**Planning & Zoning Commission
Tuesday, February 18, 2025, 6:00 PM
Public Meeting Room / Eagle Town Hall
200 Broadway, Eagle, CO 81631**

1. Project: Reserve at Hockett Gulch Phase 1B and Phase 2
File # DR24-01
Applicant: Hockett Gulch II, LLC
Location 16186 Highway 6
Staff Contact: Peyton Heitzman, Community Development Director
Request: Major Development Plan to construct 255 multifamily units, 28 townhome rental units, a clubhouse, and maintenance building. Forty-five percent (45%) of the units proposed include a deed restriction requiring local residency.

TO: Planning & Zoning Commission

REQUEST: Major Development Plan approval to construct 255 multifamily units, 28 townhome rental units, a clubhouse, and maintenance building. Forty-five percent (45%) of the units proposed include a deed restriction requiring local residency; and

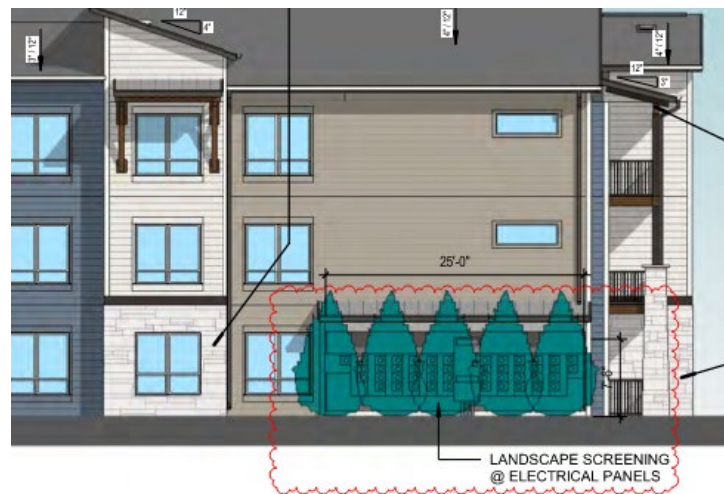
The building elevations depict electrical and utility boxes and facilities that are prominently visible on nearly all façades, negatively impacting the overall aesthetic quality of the buildings. Staff recommended that the Architectural Design Plan be revised to ensure that all electrical and utility boxes are depicted on the applicable plan sheet and that they are screened from public view, in accordance with the requirements outlined in Section 4.10.30(A)(2)(d) of the Code. Additionally, said screening methods and specifications need to be included in the materials and color palettes, building elevations within the Architectural Design Plan and/or shown on the landscape plans as applicable.

The January 14th submittal proposed screening of electrical utility boxes with landscaping as shown in the image below.

Based on the elevations, the proposed landscaping did not appear to screen the electrical utility boxes from public view as required by Section 4.10.30(A)(2)(d) of the Code. As such, staff requested that dimensions of all electrical, utility boxes and facility on the building elevations along with proposed physical screening on all applicable building elevations.

While plant materials such as trees may be an acceptable material for screening, staff remains concerned that the proposed landscaping would not completely screen the electrical utility boxes from public view. The Landscape Plan does not label the electrical utility box locations, resulting in difficulty in figuring out what type of trees are proposed for said screening. The utility boxes are 7'-6" high, ranging in width between 20 feet to 25 feet. The Landscape Plan plant schedule indicates that evergreen trees are 6' in height, which would not be tall enough to screen the utility boxes for some time. Oftentimes, trees die and require replacement. In those instances, the utility boxes would not be screened from view.

Considering the number of utility boxes, staff continues to recommend physical screening. If trees are found to be an appropriate screening method, staff recommends that all utility box locations be depicted on the Landscape Plan with the proposed tree species and requirements for sizes at the time of planting to ensure the trees screen the utility boxes from public view.

- Revise the Landscape Plan to label the locations of all electrical and other utility boxes and facilities and identify the proposed tree species and requirements for sizes at the time of planting for approval by the Director.

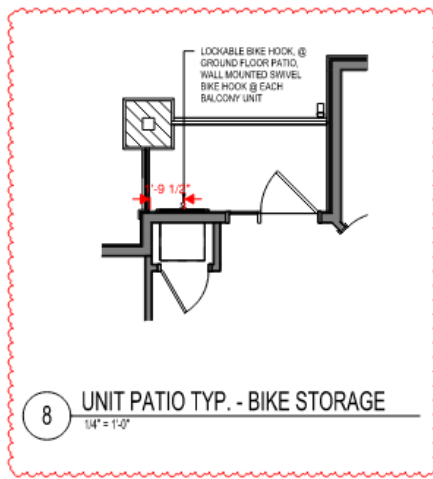
Staff has reviewed the details of the hooks and interior dimensions of the proposed storage spaces and balconies. Staff used measurements of a 29" mountain bike to determine that the proposed hooks and storage spaces could accommodate a typical bicycle used by Eagle residents. The measurements of the 29" mountain bike are roughly 6' long x 2'8" wide x 3'6" tall. It is important to note that some of the interior storage units, specifically those in Buildings 6, 9, and 10 are only able to accommodate a bicycle where the hook is shown because the hook swivels. The only important note from staff's review of the long-term bicycle parking is that the locking hooks provided on the patios require the bicycle to hang from the center of the frame, depending on the height of any walls around the patio, the bicycle may not have enough space to hang in this way. Staff is including a condition of approval for the applicant to provide greater clarity on the first-floor patios with locking bike hooks.

- Applicant to provide additional detail regarding placement of bicycle hooks on first floor patios. Bicycle hooks must be placed in a location to accommodate a 6' long bicycle.

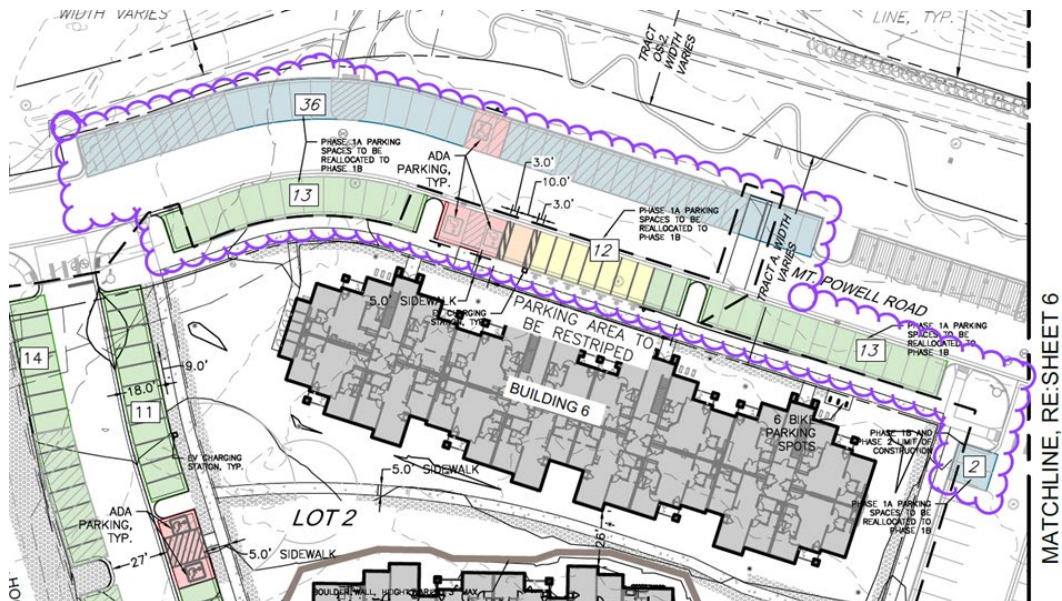
Staff has reviewed the parking plan to ensure that the required 538 parking spaces have been provided. During Phase 1A, 76 parking spaces were constructed to serve Phase 1B. Those 76 spaces have been clouded in purple in the image below:

Single Garage and Double Garage with 2024 Toyota Tacoma Trucks (17'8"long x 6'6"wide)

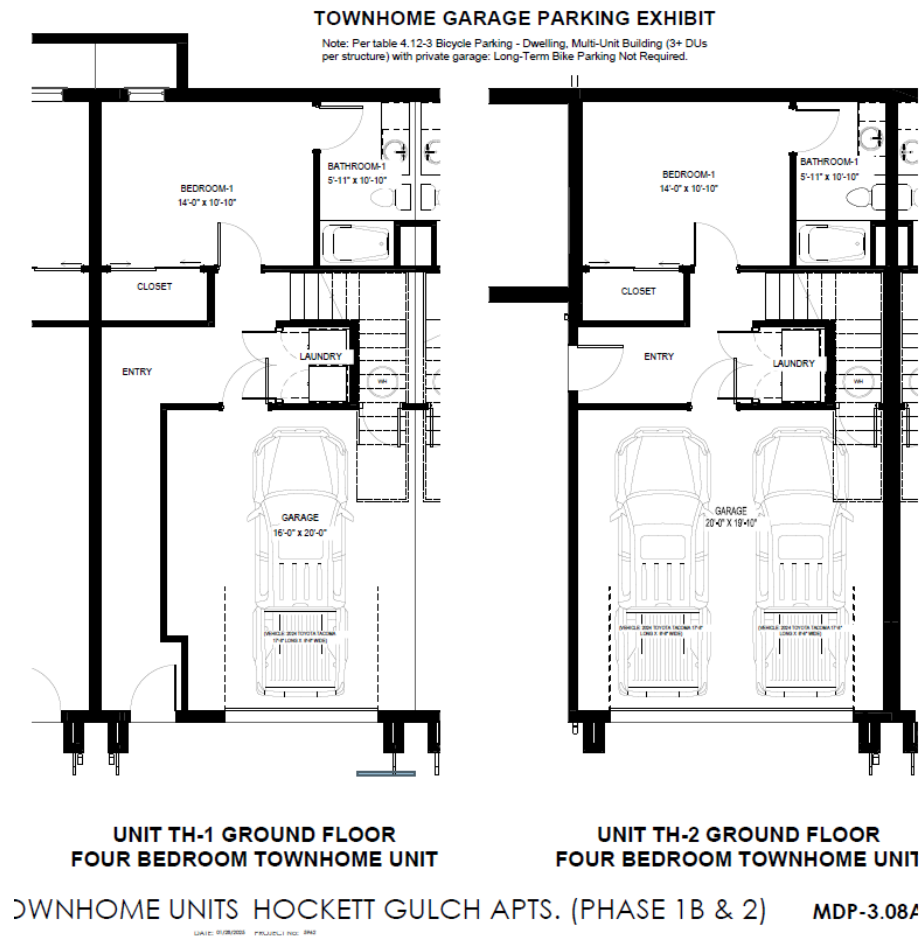
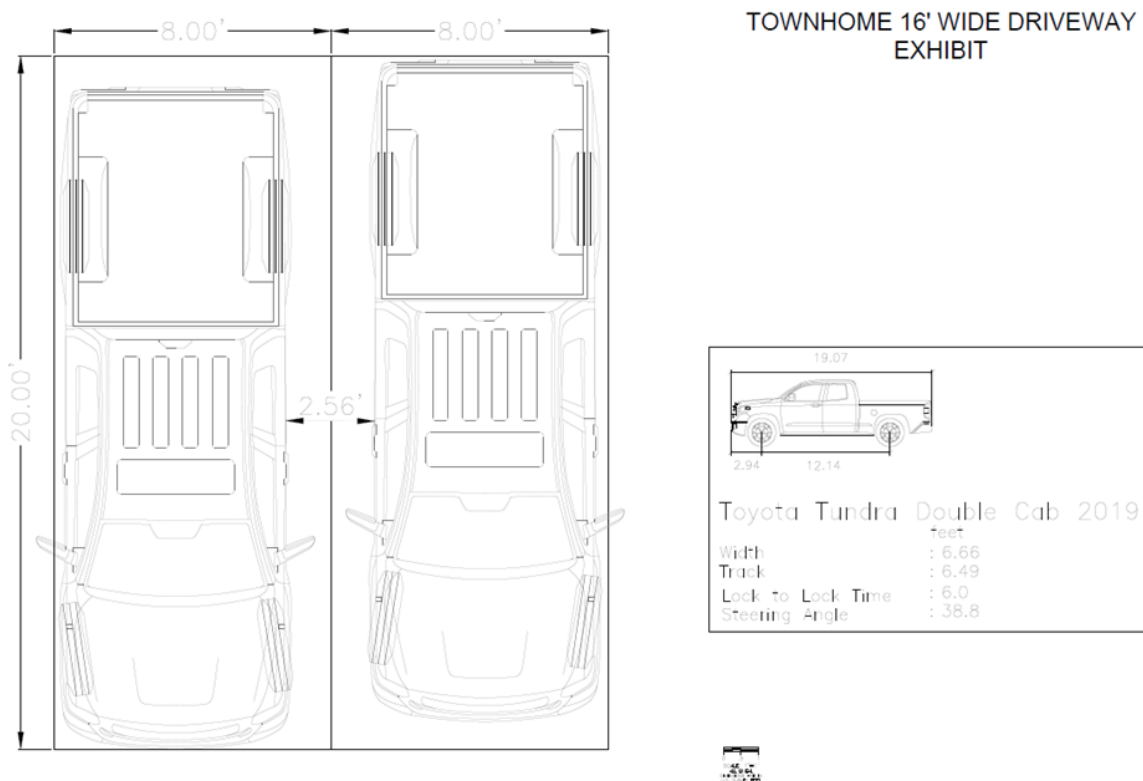
The townhomes are served by 28 private garages. The end units have 2-car garages and all other units have 1-car garages. As tandem parking is permitted per the PUD Guide, the driveways are proposed to fulfill the 3 spaces per dwelling unit requirement equating to 72 parking spaces for all townhomes. This results in a 12-parking space deficiency for the townhomes, of which the applicant is proposing the spaces be provided elsewhere on the site. It's important to note that the townhome owners cannot be assigned the required parking spaces per dwelling unit as the PUD Guide prohibits the assignment of parking spaces other than for garages.

Additionally, as noted above both the Code and the PUD Guide allow for compact vehicle spaces and the Code further defines an off-street parking space as not less than 9' wide by 19' long. The driveways for the end unit townhomes are effectively compact parking space. Staff raised this observation with the applicant and suggested they provide exhibits showing two typical vehicles in Eagle side by side in both the driveway and the garages.
